AP1000 DOCUMENT NO.	REVISION	PAGE	ASSIGNED TO	OPEN ITEMS (Y/N)
APP-GW-GLR-134	1	1 of 470	W-Sterdis

TITLE: **AP1000 DCD Impacts to Support COLA Standardization**

AP1000 Standard Combined License Technical Report

Containment Penetrations
Fuel Transfer Penetration

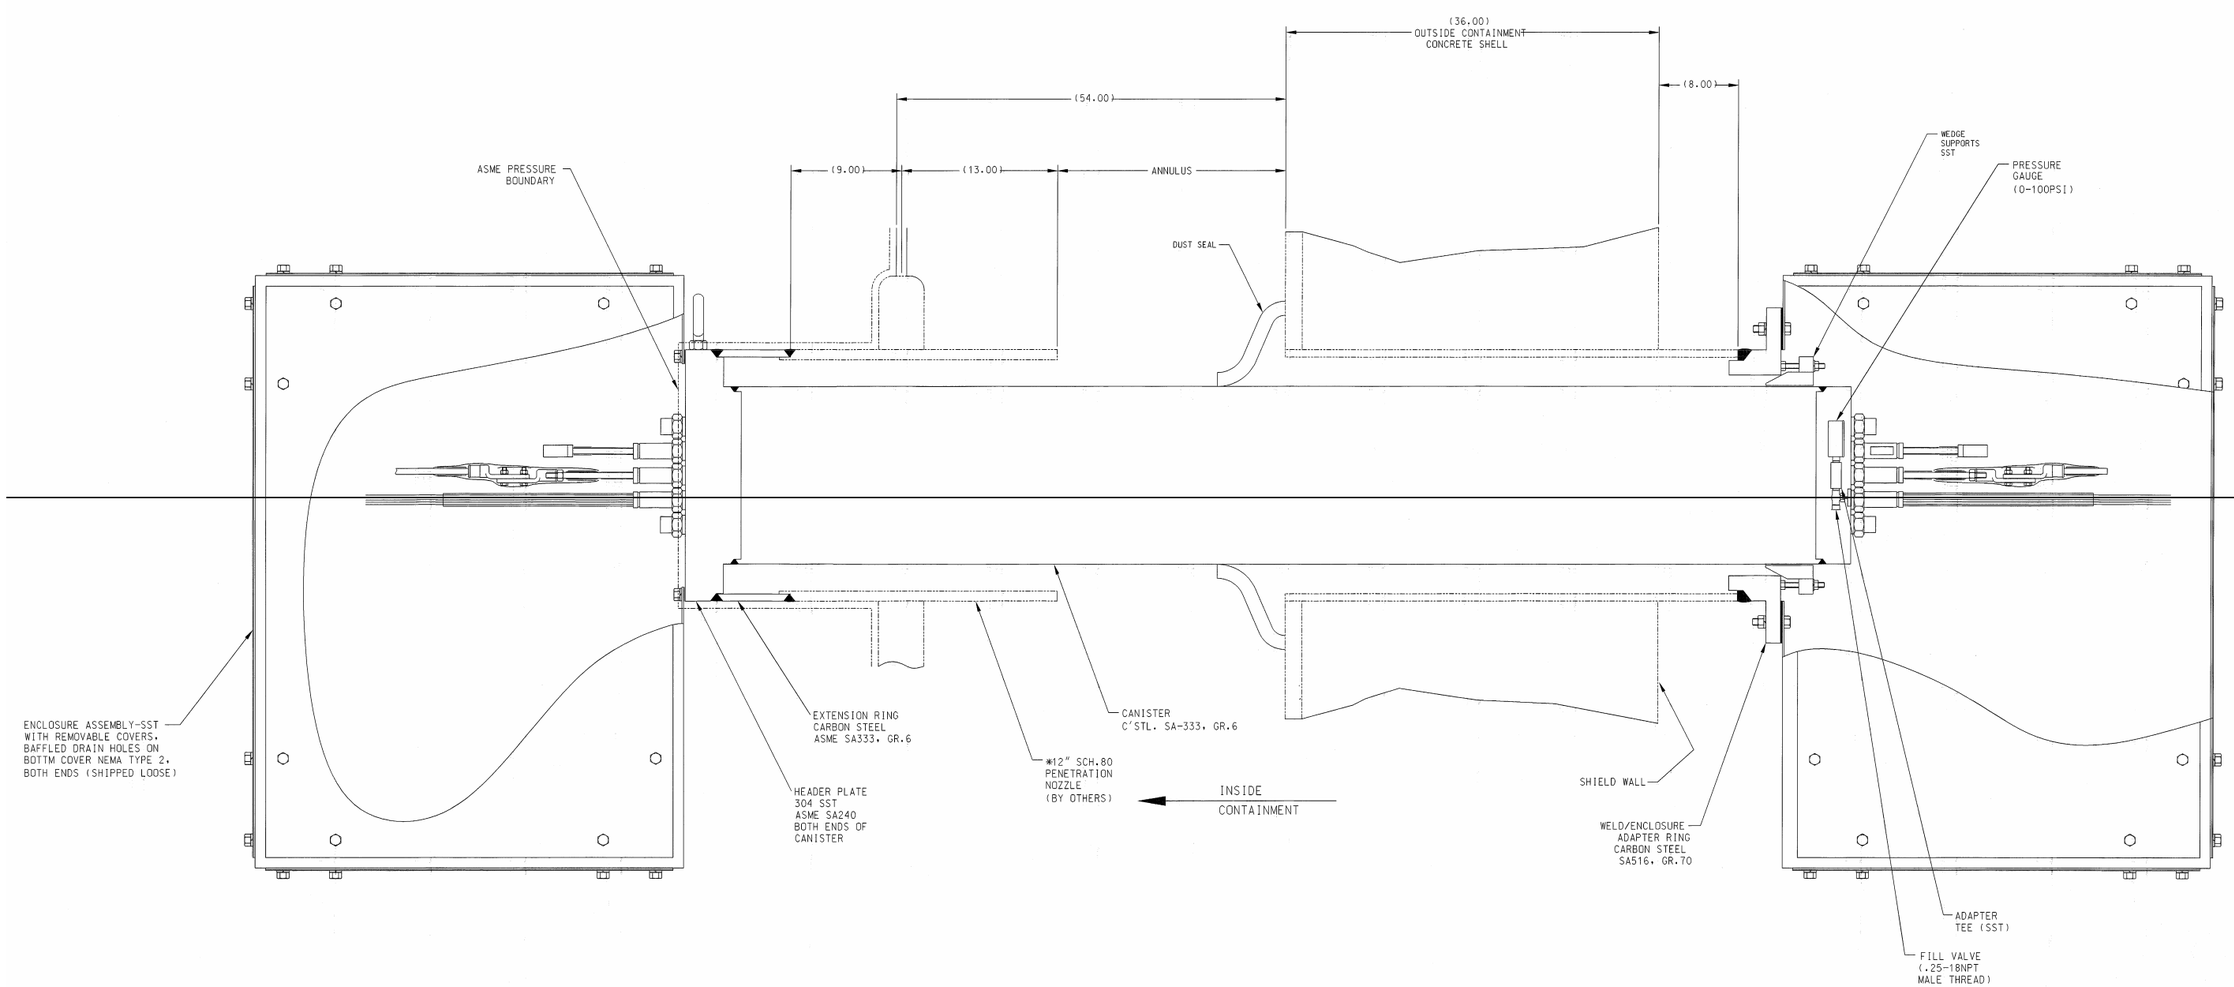
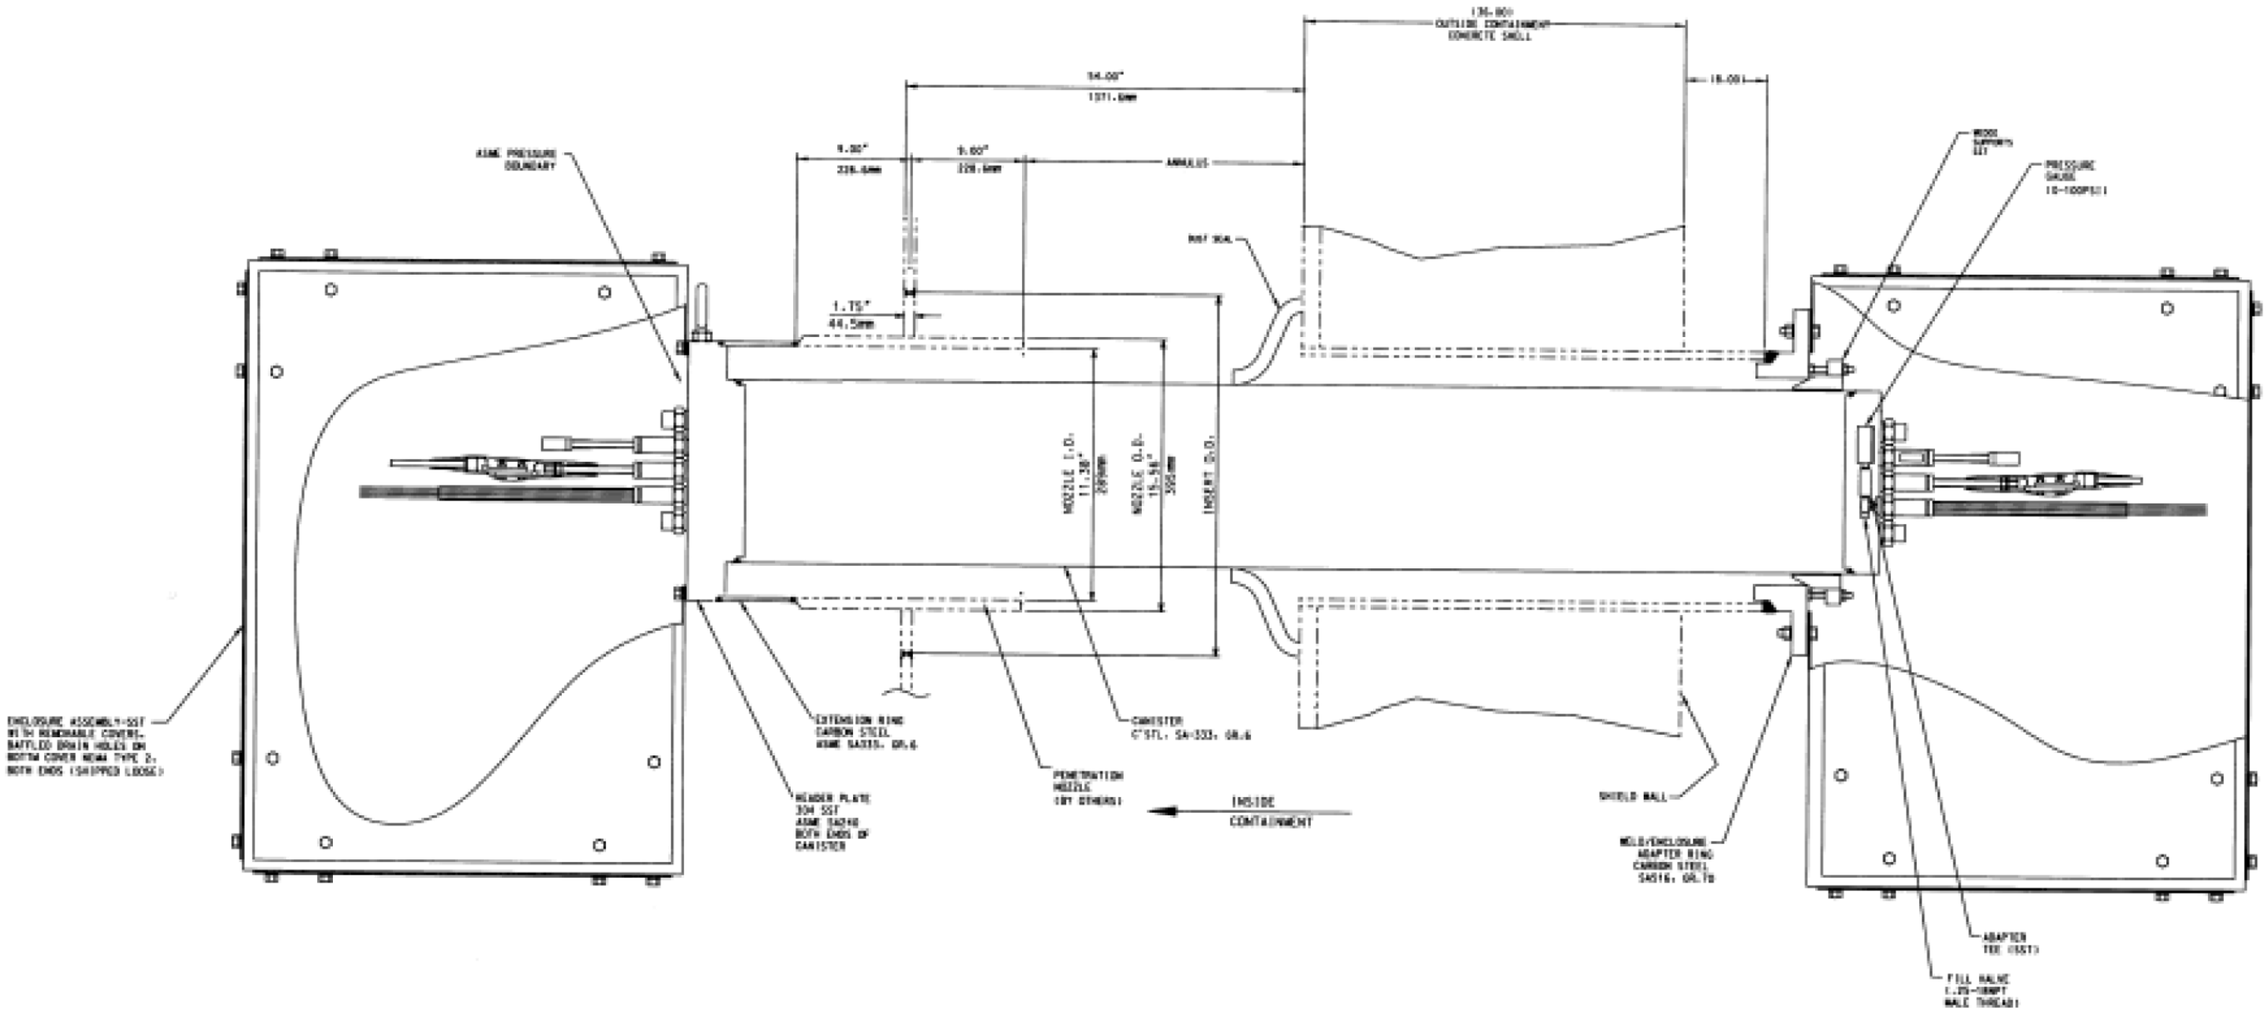
NRC044 contains corrections to Table 3.2-3, Figure 3.8.2-4 of DCD Revision 16. The basis for the change is RAI-TR09-003.

Figure 3I.1-1

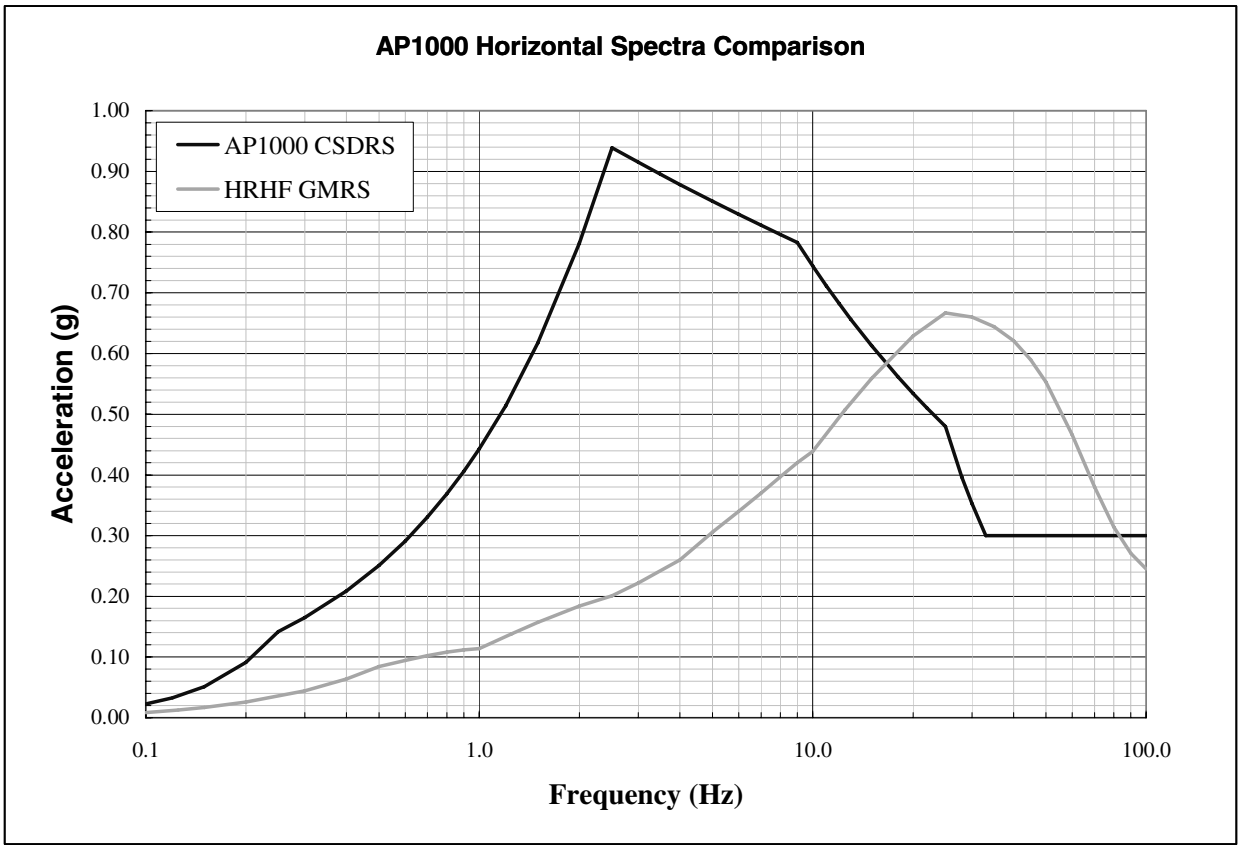
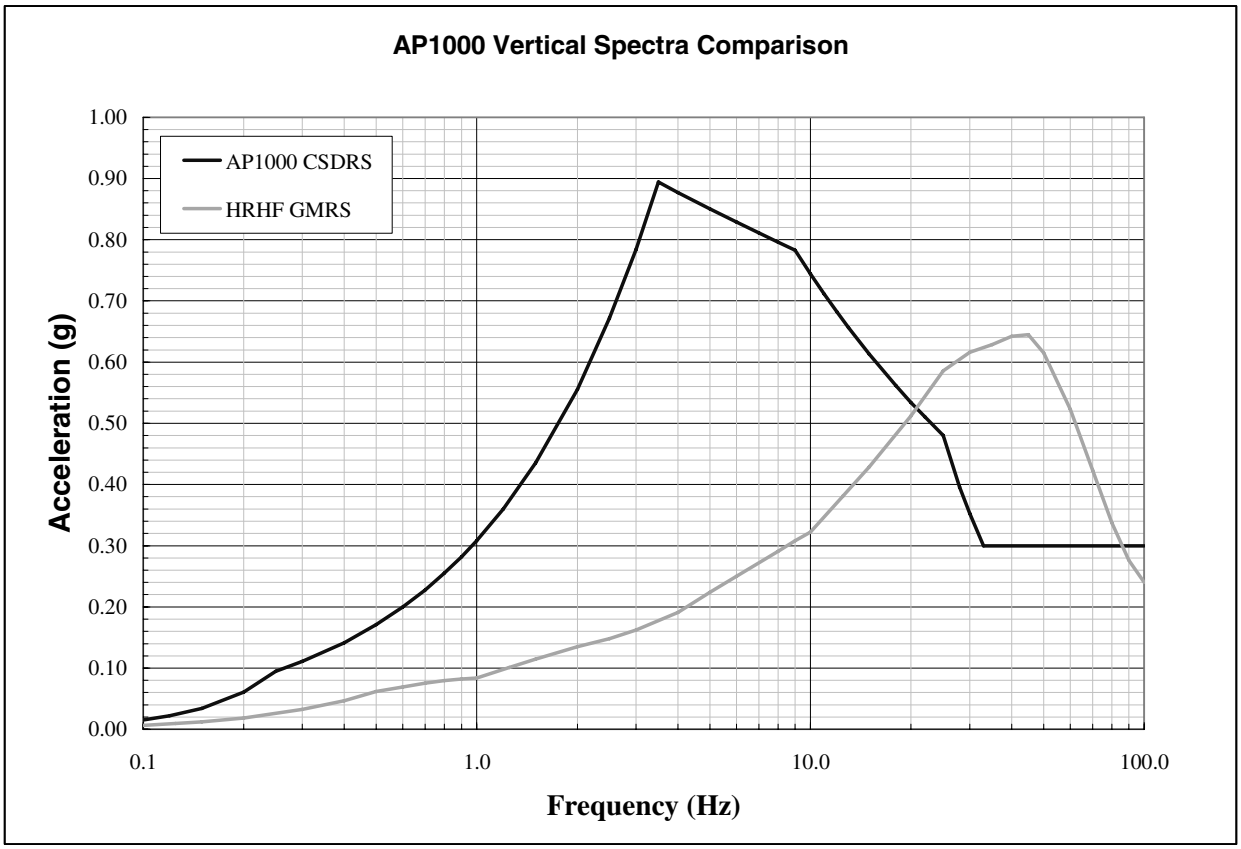
Comparison of Horizontal AP1000 CSDRS and ~~Bellefonte~~ HRHF GMRS

Comparison of Vertical AP1000 CSDRS and ~~Bellefonte~~ HRHF GMRS

Figure 4.2-6

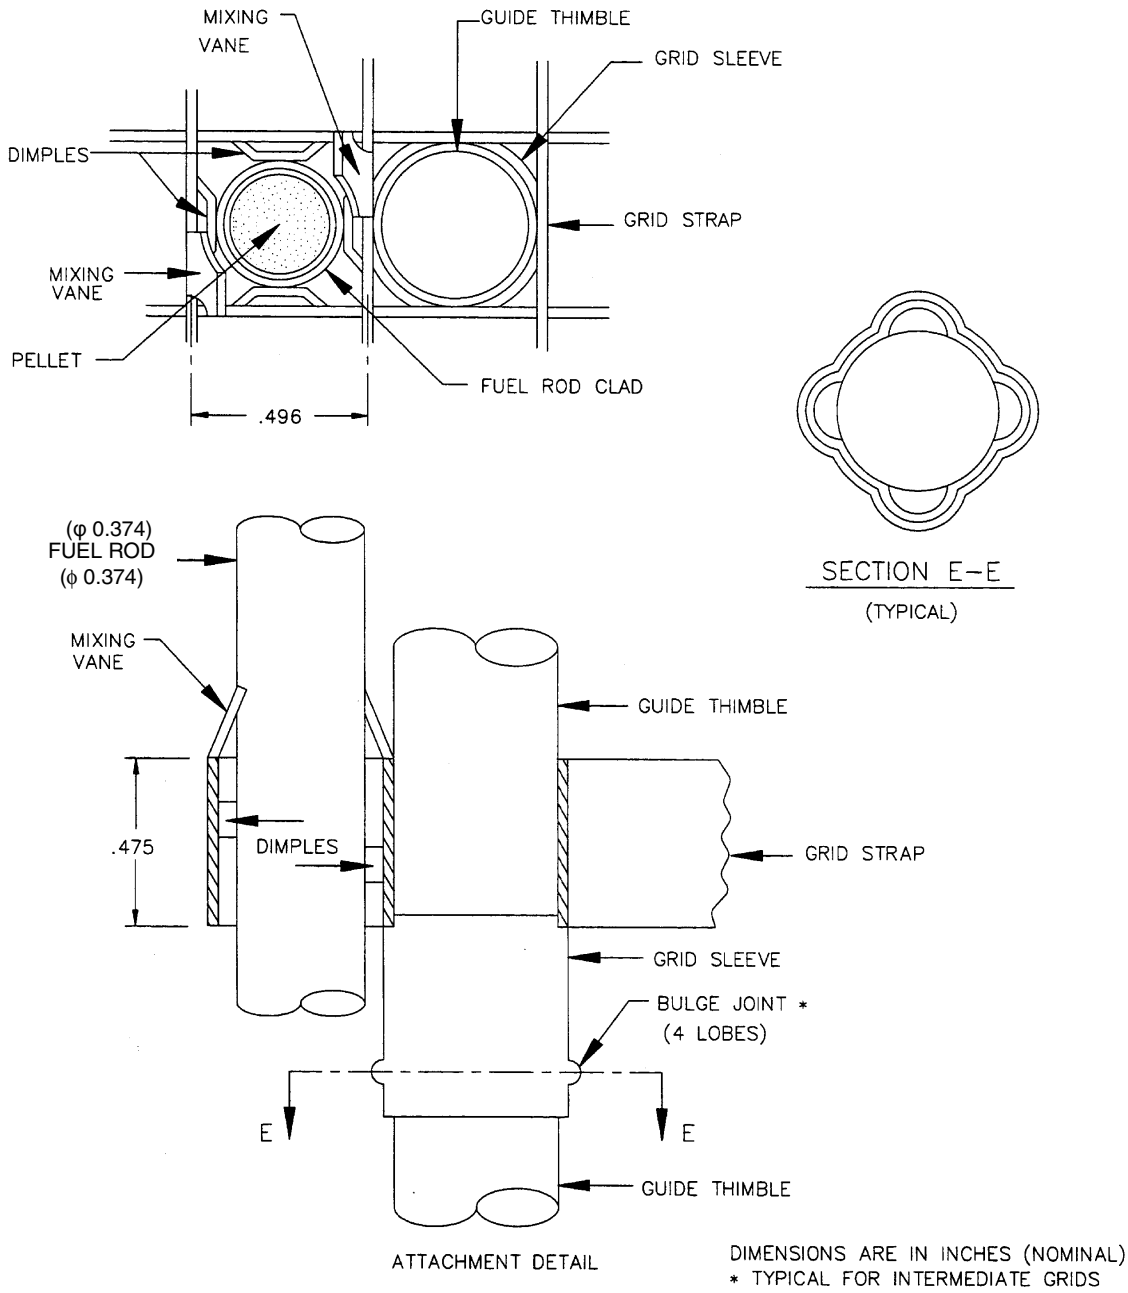
NRC165 contains addition of fuel rod dia to Figure 4.2-6 to be consistent with RAI-TR18-SRSB-06

Figure 5.1-2

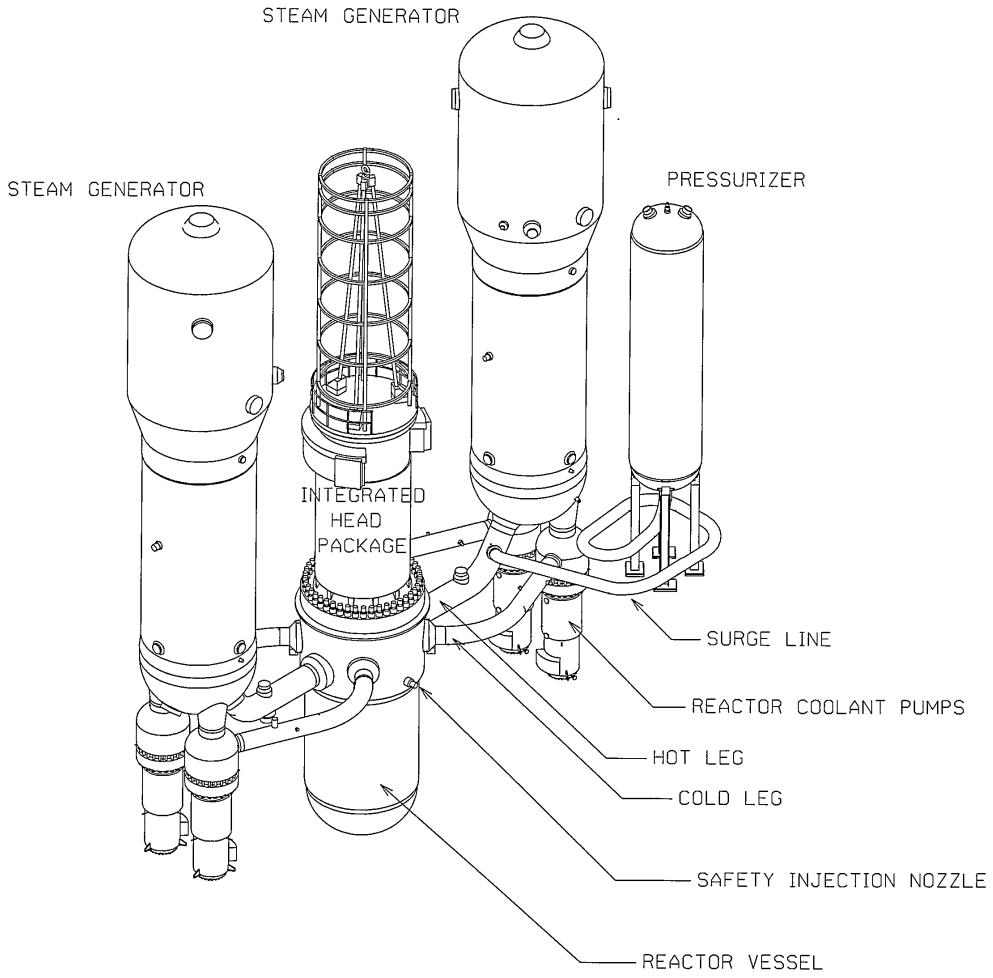
NRC106 contains corrections to Figure 1.2-1, 5.1-2 and Figure 1.2-9. The basis for the change is TR36 APP-GW-GLR-016.

Figure 5.3-6

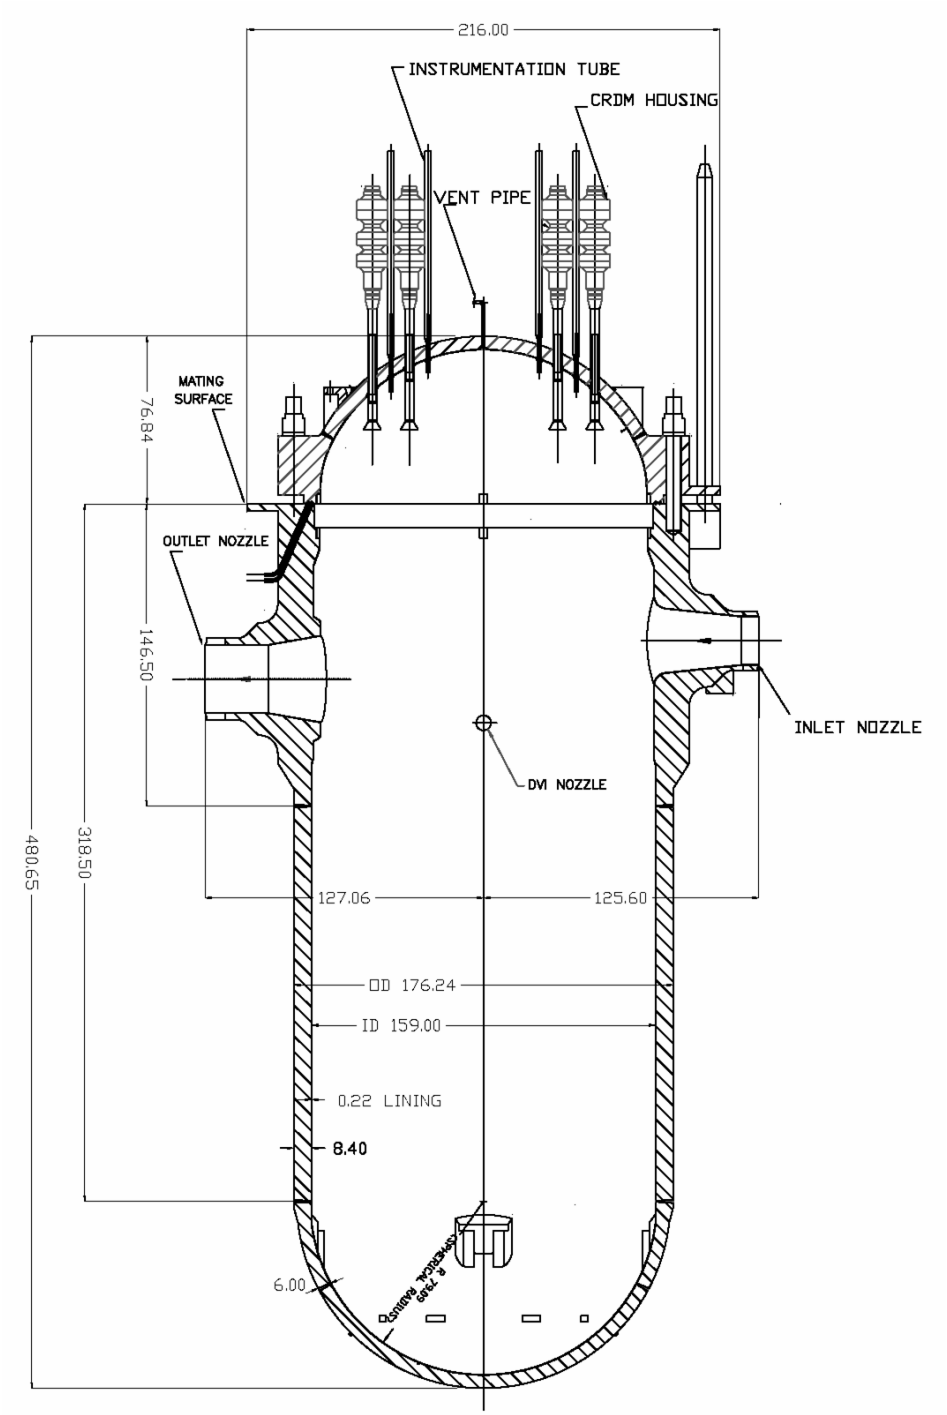
NRC115 contains editorial corrections to Sub-sections 5.2.1.3, 5.2.4.3 and Figure 5.3-6 of DCD Revision 16.
